# Thames Tideway

## Measures to protect the river environment from the adverse effects of waste water discharges

**Professor Chris Binnie**

**22nd October 2013**

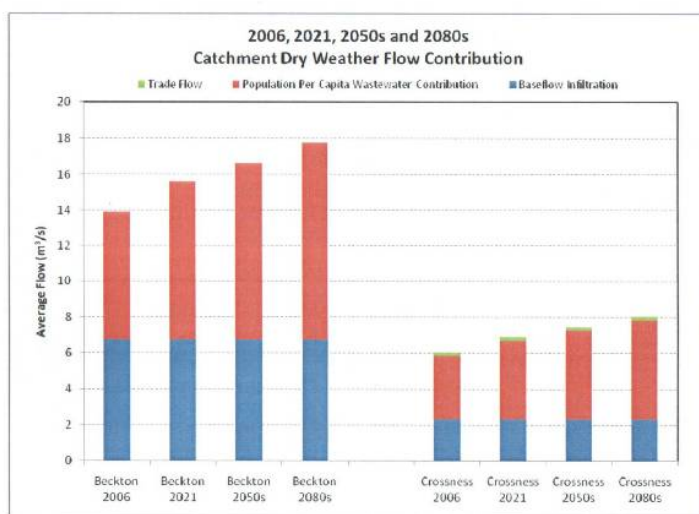
Hammersmith Pumping Station spills. The period from 1st October 2012, to 24th October 2013 ie 12.6 months, then Hammersmith pumping Station spilt 27 times, ie 25 times a year on average.

This compares with the 50 times a year quoted in the TW CSO spill frequency analysis for Hammersmith. CEH, in their September 2013 Hydrological summary state that for the Thames catchment this period up to 1<sup>st</sup> October 2013 has 107% of average rainfall so it is wetter than normal. Thus one would have expected the number of spills during this period to have been above the average. This does seem to show evidence that the spill frequency in the TW model for Hammersmith of 50 times a year is very likely to be appreciably higher than reality and the real figure could be about half that shown in the TW Table in Appendix A.

Thus, in my view, this is strong evidence from TW that the sewer system model should be looked at again to recalibrate against the more recent actual spill data. One could then use the revised model to identify what measures would be needed to meet the EC spill frequency criterion.

FIG. 1 (above)—PLAN OF THAMES-LEE TUNNEL MAIN (below) LONGITUDINAL SECTION

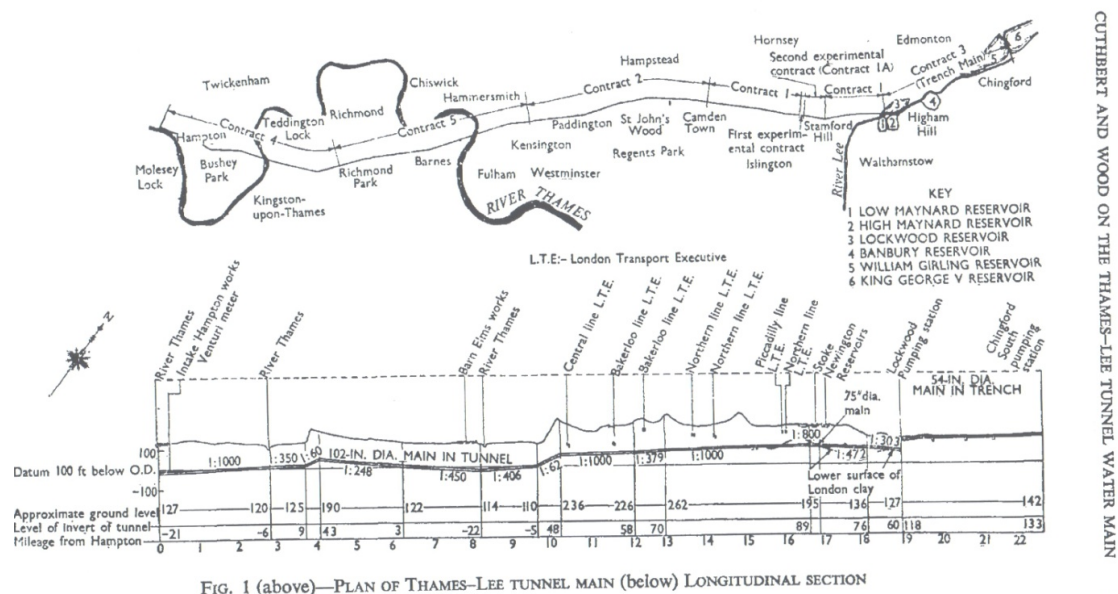
Were it possible to divert storm water into this tunnel, then it would reduce the flow to the sewer interceptors. A separate storm water system would need to be identified, and possibly developed, and connected. Places that could be considered might be based on Holland Park, Kensington Gardens, and Hampstead Heath. It is possible that inlet screening would be necessary. Delivery would be to the Lee Valley reservoirs where considerable dilution and some natural treatment would occur. Coppermills water treatment works provides advanced water treatment.

Such a scheme could also collect runoff during a dry spell and provide some increase in water resources. I believe such a system has not yet been considered but should be.

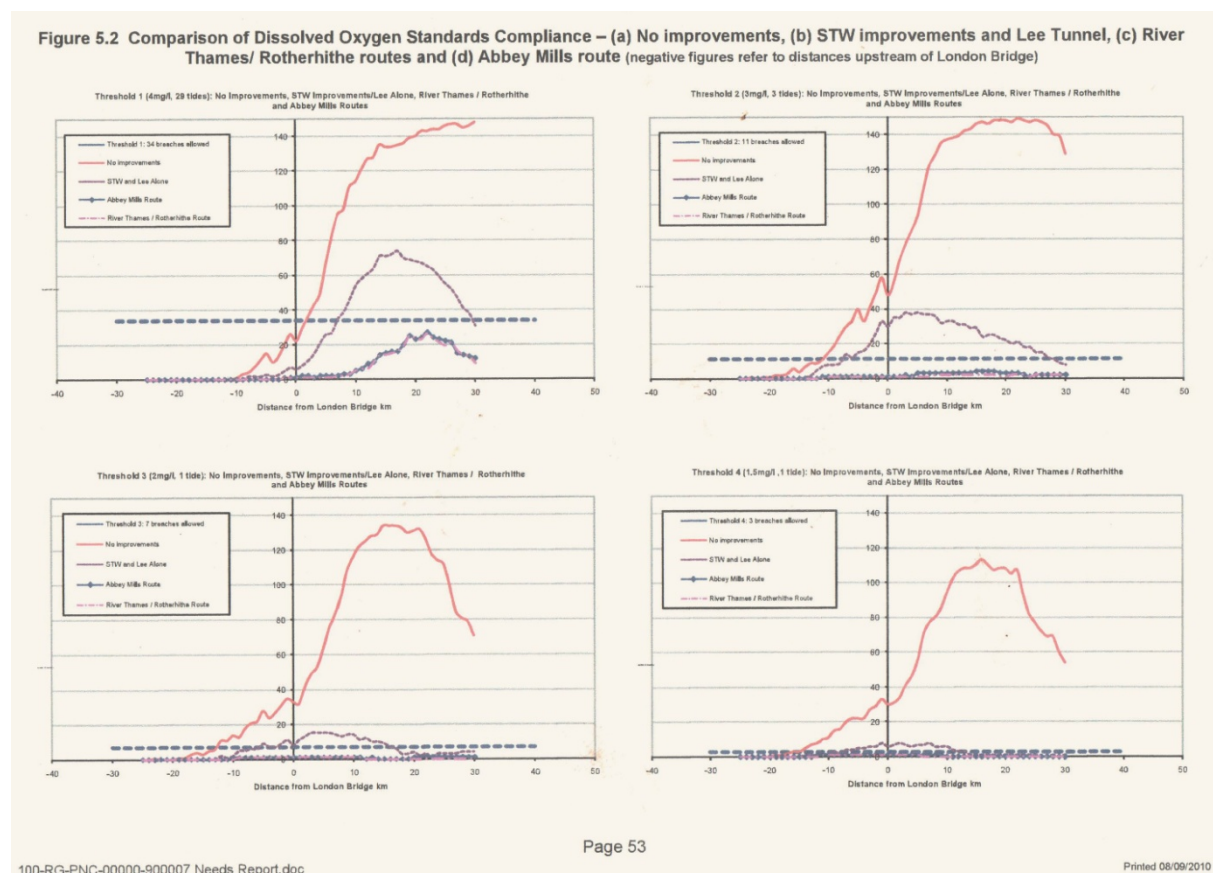
It should be noted that 4mg/l one week standard *“was selected to ensure protection against chronic effects; these would include e.g. effects such as depression of growth and avoidance of hypoxic area.”* Tideway Fisheries Review Jacobs 2009 page 5. Thus the 4mg/l standard would not cause any fish mortality but could delay any salmon trying to migrate at the time of any failure of Threshold 1.

As can be seen from the histogram below the threshold 1, 4mg/l standard, is not driven by fish mortality but largely by avoidance, particularly by during their annual migration.

Threshold 1, 4mg/l, is only there in that salmon tend to avoid such conditions. It is not there to protect against any fish mortality. Looking at the plots of the Threshold 3 and 4 criteria, the lower two graphs, then one would **currently** expect regular extensive fish kills in the river downstream of London Bridge. I have been unable to identify such reports. There have been reports of considerable fish kills in the Chiswick area on 3<sup>rd</sup> August 2004 and in 2011. Those fish kills were caused by Mogden STW effluent, probably activated sludge carry over and that has now been dealt with. Thus one could speculate that the model may well over predict the impact on fish or that fish find ways to avoid such polluted areas. There is some evidence to support that view as after the 2004 event fish species are reported by Dr Turnpenny to have moved downstream.

**Figure 3.1. Seasonal pattern of trap catches at Molesey, totals for date. a) 1986-1996, b) 1986-1993, and c) 1994-2008.**

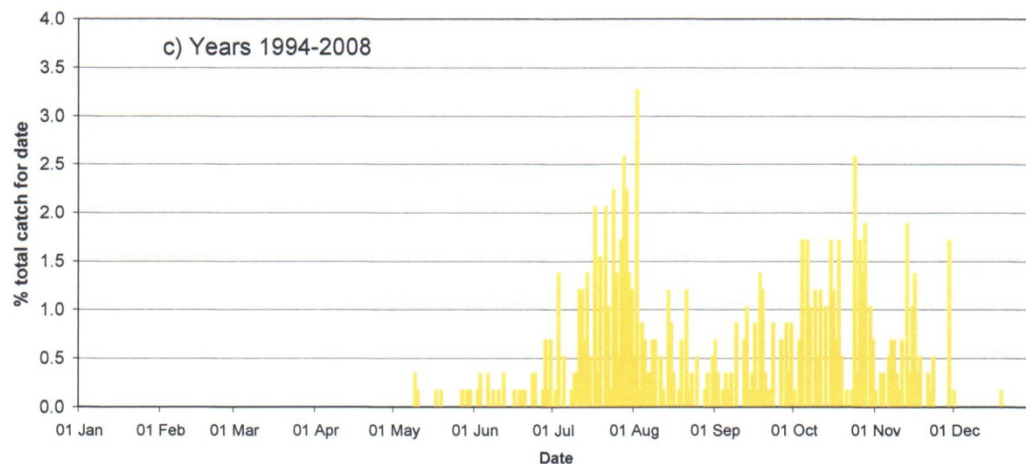
The one failure is salmon at the 3mg/l where a 90% mortality is assumed with a risk factor of 69%. As I understand it this implies that 69% of the whole salmon stock are resident in the Tideway at the time of the event. First salmon return to the river after one or two seasons in the North Atlantic. Below is the frequency of trap catches at Molesey weir.

Salmon are migrants over a period of from June to November, see Solomon page 15 above. It should not normally take a salmon more than a few days during this period to swim the length at risk. Some salmon at certain times of the year can be put off from traversing due to temperature or dissolved oxygen conditions. However the fish trials showed salmonids have a good ability to avoid hypoxic zones. Further the percentage mortality allowed for salmon is 30%, [Tideway Fisheries Review 2009](#) page 23.
